DUNE Infrastructure Grounding Plan – Changes due to removal of rock septum

T. Shaw
11 April 2018

DUNE Grounding Infrastructure

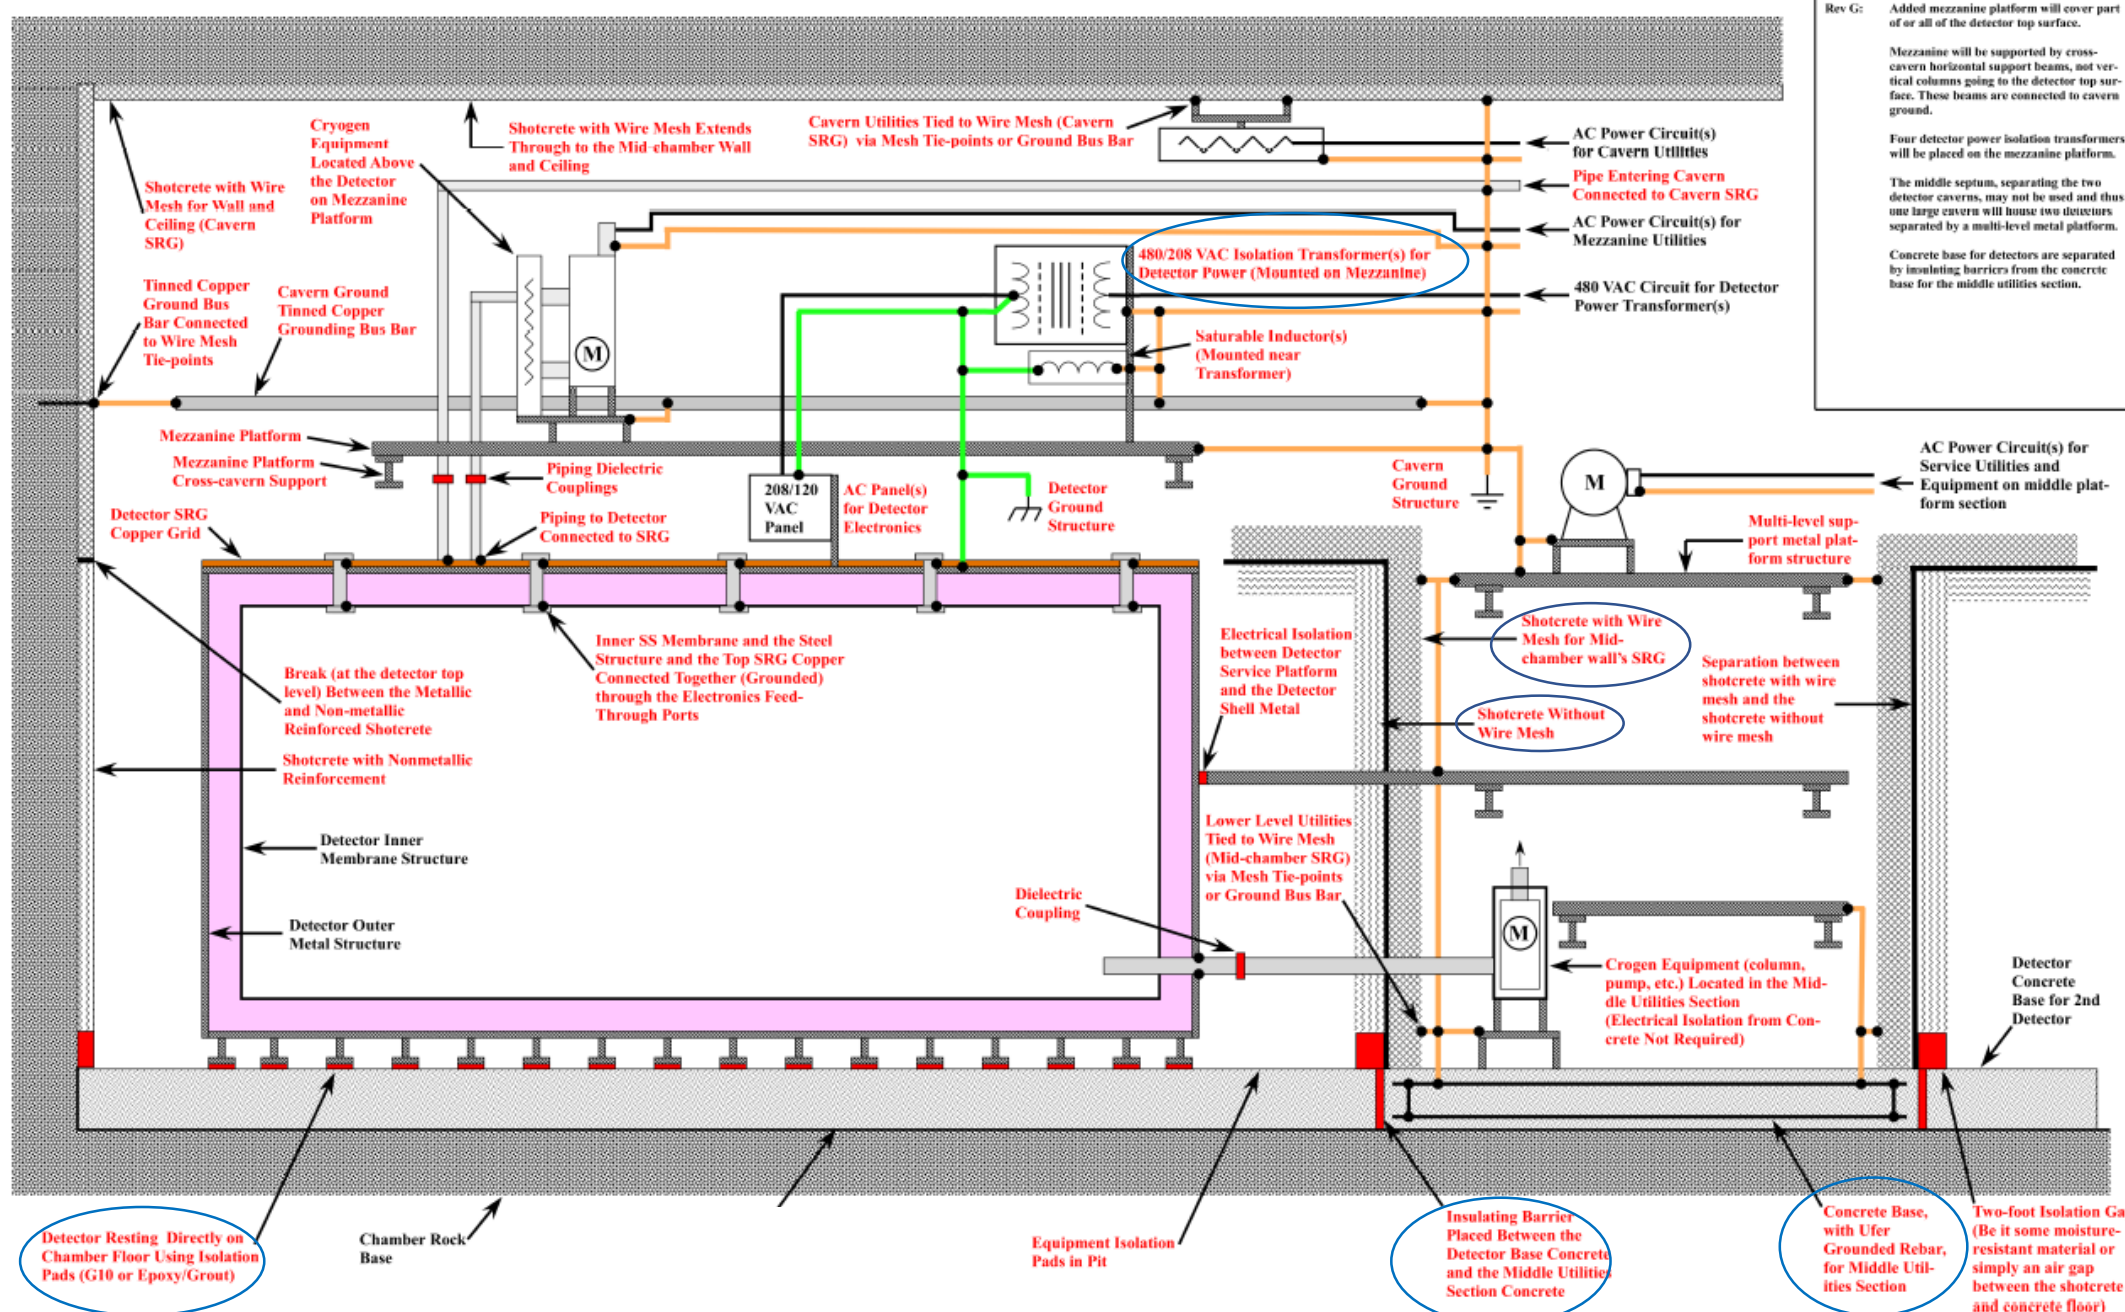
- Change requests due to removal of the rock septum
 - The new lower level mid-chamber floor will remain part of the **UFER Ground**. The newly created mid-chamber wall, shall contain wire mesh and be part of the **Cavern Ground**. The mid-chamber-wall shall provide a well bonded path between the central access drift **UFER Ground** and the mid-chamber floor **UFER Ground**.
 - Concrete pours between the cryostat/chamber pad areas and the mid-chamber area between the cryostat pads shall be isolated from each other. Use of a high resistive rubber barrier, or equivalent, is required.

Rev G: Added mezzanine platform will cover part of or all of the detector top surface.

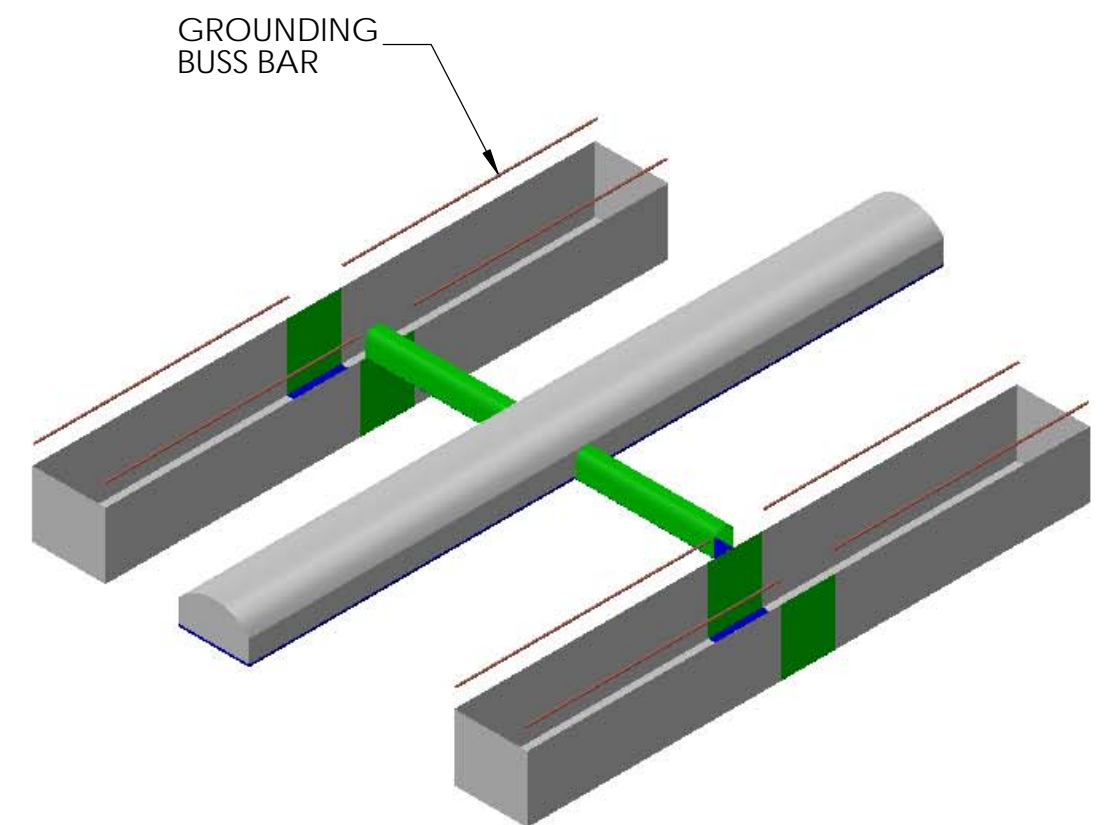
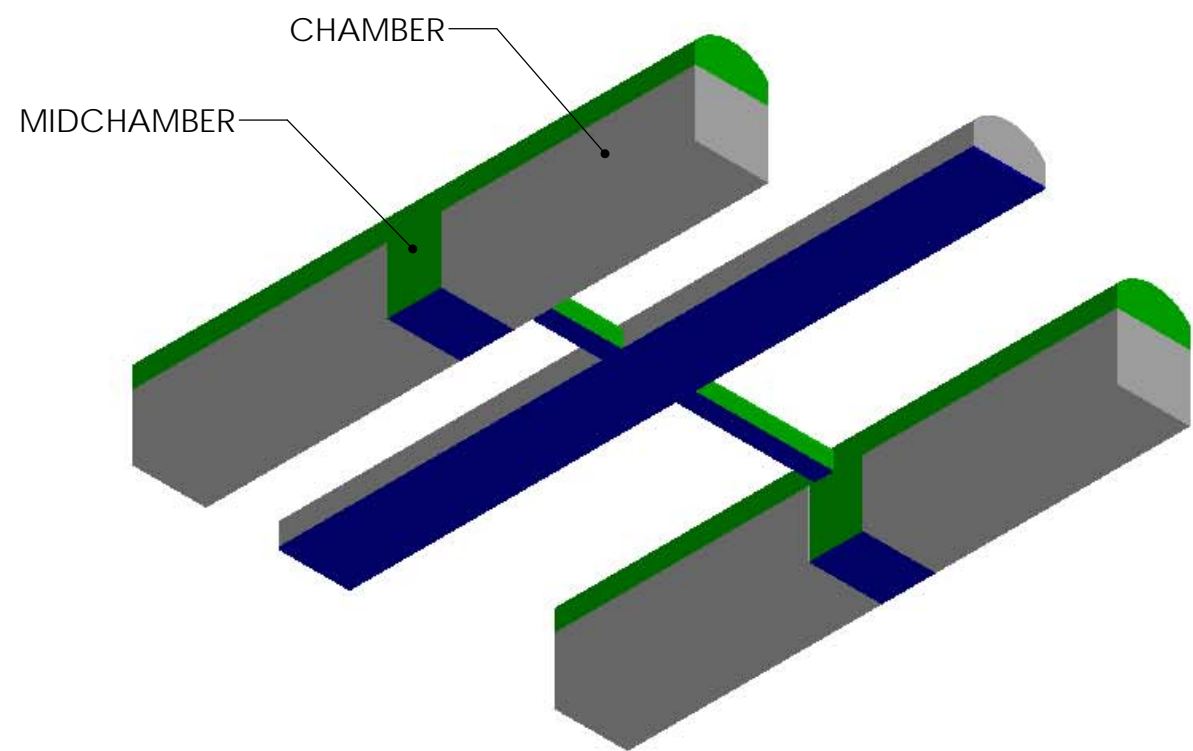
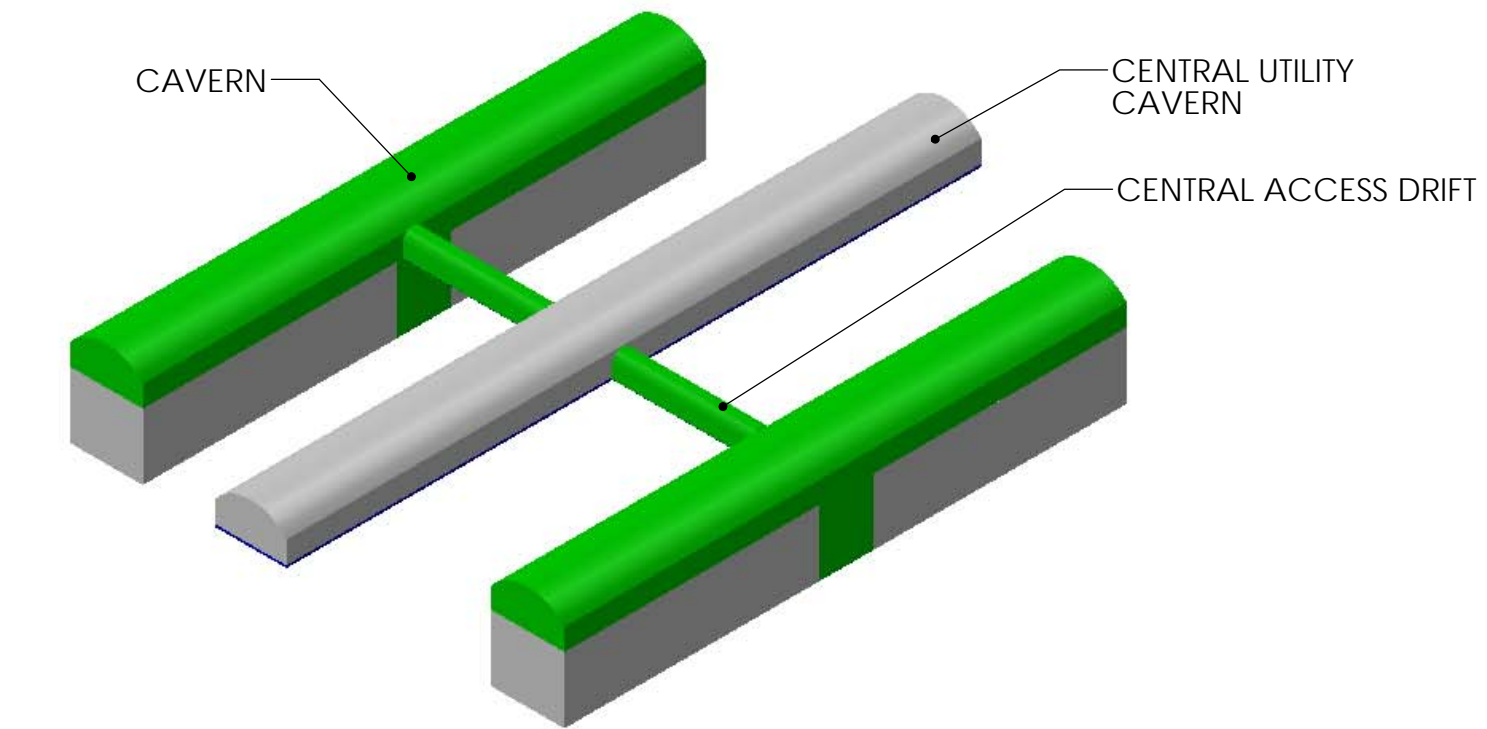
Mezzanine will be supported by cross-cavern horizontal support beams, not vertical columns going to the detector top surface. These beams are connected to cavern ground.

Four detector power isolation transformers will be placed on the mezzanine platform.

The middle septum, separating the two detector caverns, may not be used and thus one large cavern will house two detectors separated by a multi-level metal platform.

Concrete base for detectors are separated by insulating barriers from the concrete base for the middle utilities section.
